World Forum for Harmonization of Vehicle Regulations**Working Party on Passive Safety Provisions****Seventy-first session**

UN Regulation No. 129 (Enhanced Child Restraint Systems)**Proposal for Supplement 8 to the 03 series of amendments****Submitted by the expert from the European Association of Automotive Suppliers***

Figure 1
Conditioning for adjusters mounted directly on Enhanced Child Restraint Systems

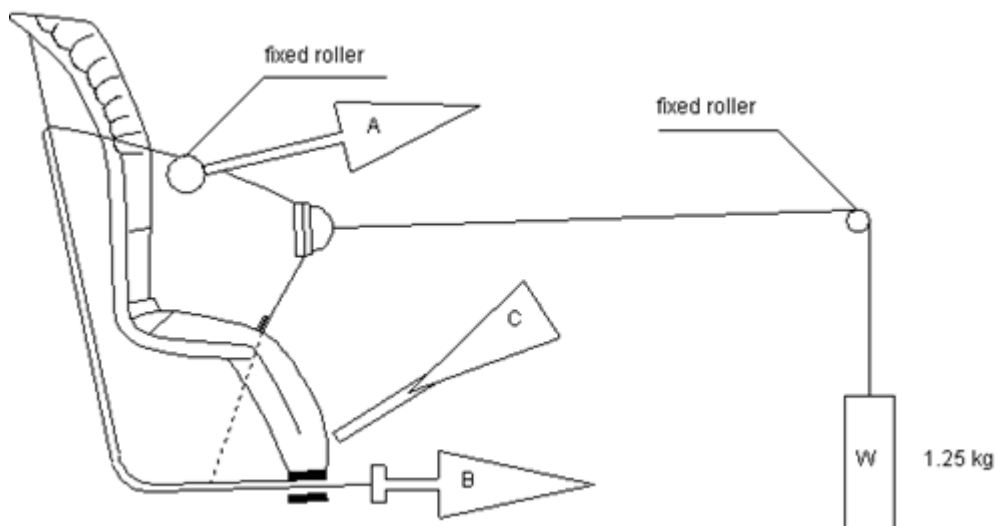
1. **Conditioning for adjusters mounted directly on Enhanced Child Restraint Systems (Figure 1)**
 - 1.1. **Method**
 - 1.1.1. With the webbing set at the reference position described in paragraph 7.2.6.1., withdraw at least 50 mm of webbing from the integral harness by pulling on the free end of the webbing.

- 1.1.2. Attach the adjusted part of the integral harness to the pulling device A.
 - 1.1.3. Activate the adjuster and pull at least 150 mm of webbing into the integral harness. This represents half of one cycle and puts pulling device A to the maximum webbing extraction position.

- 1.1.4. Connect free end of webbing to pulling device B.
 - 1.2. **The procedure of the cycle is:**
 - 1.2.1. Pull B at least 150 mm while A exerts no tension on the integral harness.

- 1.2.2. Activate the adjusters and pull A while B exerts no tension on the free end of the webbing.
 - 1.2.3. At the end of stroke, de-activate the adjuster.

- 1.2.4. Repeat cycle as specified in paragraph 6.7.2.7. of this Regulation.

Conditioning for adjusters connected to a strap (not directly mounted on Enhanced Child Restraint Systems)

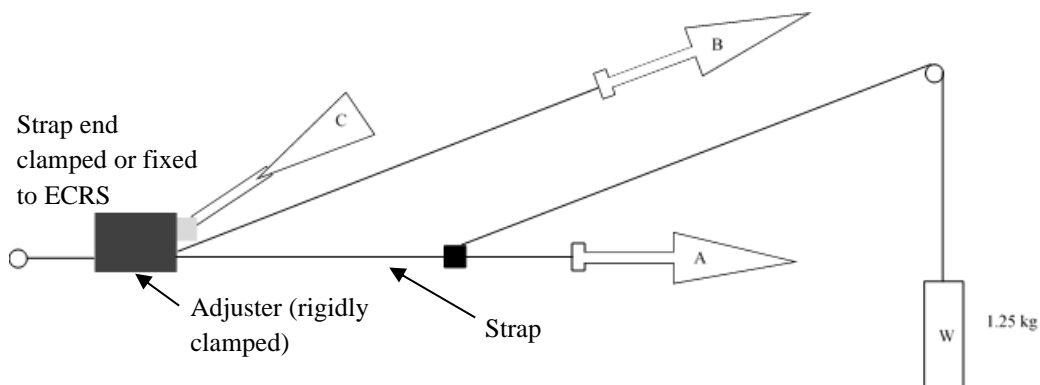
2. **Conditioning for adjusters connected to a strap (not directly mounted on Enhanced Child Restraint Systems) (Figure 2)**
 - 2.1. **Method**
 - 2.1.1. Rigidly clamp the adjuster
 - 2.1.2. With the strap set at the reference position described in paragraph 7.2.6.2., withdraw at least 50 mm of strap from the adjuster by pulling on the free end of the strap.
 - 2.1.3. Attach the adjuster part of the strap to the pulling device A.
 - 2.1.4. Activate the adjuster (C) and pull at least 150 mm of strap through the adjuster. This represents half of one cycle and puts pulling device A to the maximum strap extraction position.
 - 2.1.5. Connect the free end of the strap to pulling device B.
 - 2.2. **The cycle is:**
 - 2.2.1. Pull B at least 150 mm while A does not exert tension on the strap.

- 2.2.2. Activate the adjuster (C) and pull A while B does not exert tension on the free end of the strap.
- 2.2.3. At the end of the stroke, de-activate the adjuster.
- 2.2.4. Repeat the cycle as specified in paragraph 6.7.2.7. of this Regulation."
